**REMARKS**

Claims 3-7 and 9-20 are pending in the present application. Claim 3 is the sole remaining independent claim. By this Amendment, Applicant cancels claims 1, 2, and 8.

Fig. 1

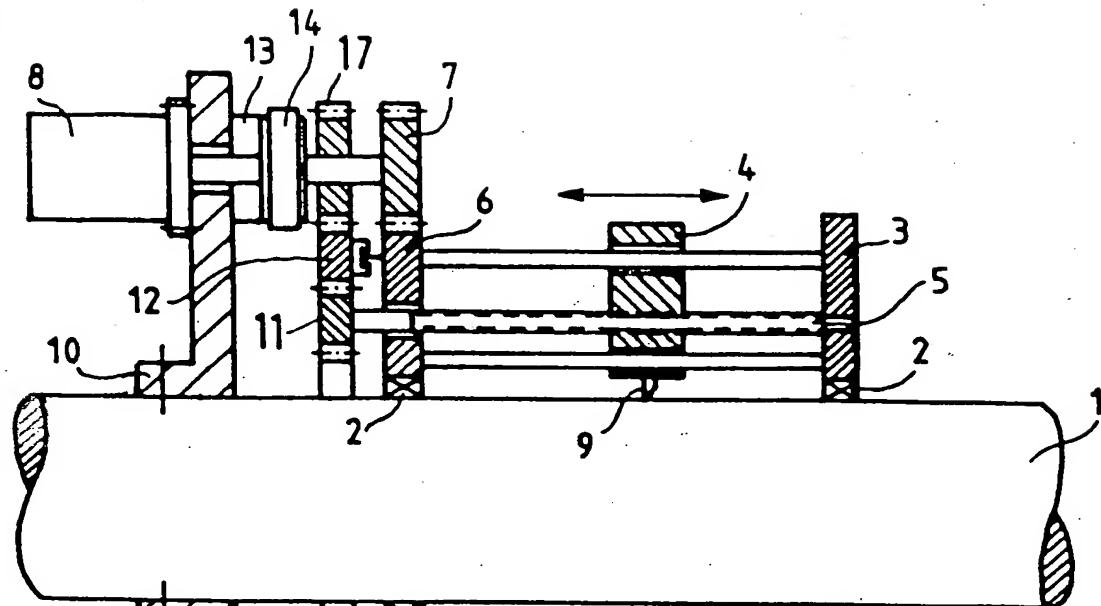
An exemplary, non-limiting embodiment of the toothed gears is shown in Fig. 1 (which is a schematic side view). Here, the gear rings 12, 6 are shown in cross-section. The gear ring 12 has internal and external teeth, while the gear ring 6 has external teeth only. The inward facing side of the gear ring 6 abuts against a bearing 2 (and therefore no teeth are necessary). See the marked up Fig. 1.

As explained in paragraph [0021], the gear ring 6 is part of the frame support 3. And as shown in Fig. 1, the gear ring 6 confronts the gear ring 12, and an element (not labeled) is interposed therebetween. This element may rotatably couple the gear ring 12 to the gear ring 6 (and thus to the frame support 3). This rotatable couple feature is also defined by claim 10.

The Examiner also believes that the gear ring 12 is nested in the pinion 17. However, Figs. 1 and 2 clearly show that the pinion 17 is located on the radial outside of the gear ring 12.

Fig. 2

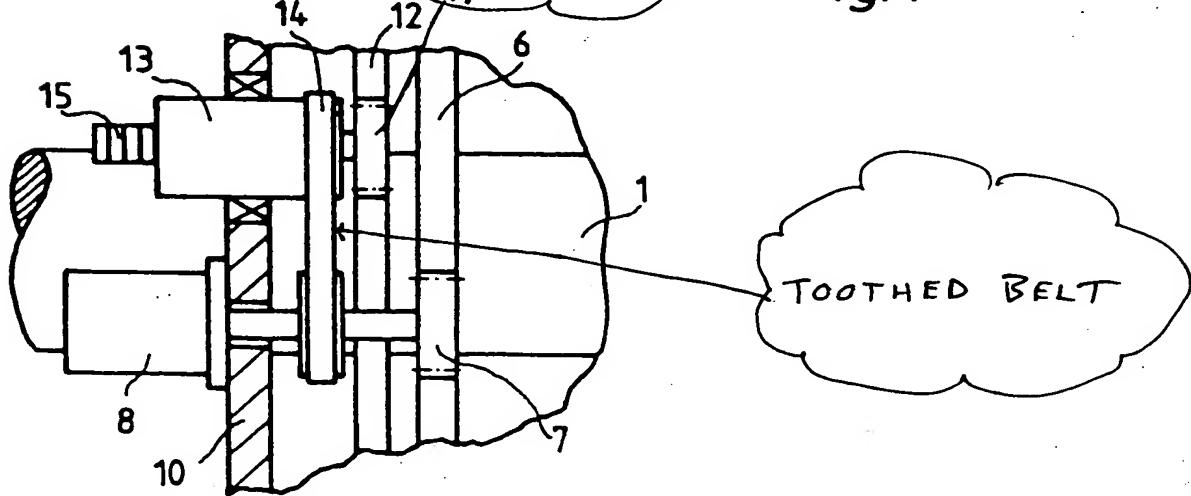
An exemplary, non-limiting embodiment of the coupling between the main motor and the *housing* of the support motor is shown in Fig. 2 (which is a top view of Fig. 1). Here, as explained in paragraph [0022], the main motor 8 is coupled to the *housing* of the support motor 13 via the toothed belt 14. The toothed belt 14 is the coupling. See the marked up Fig. 2.
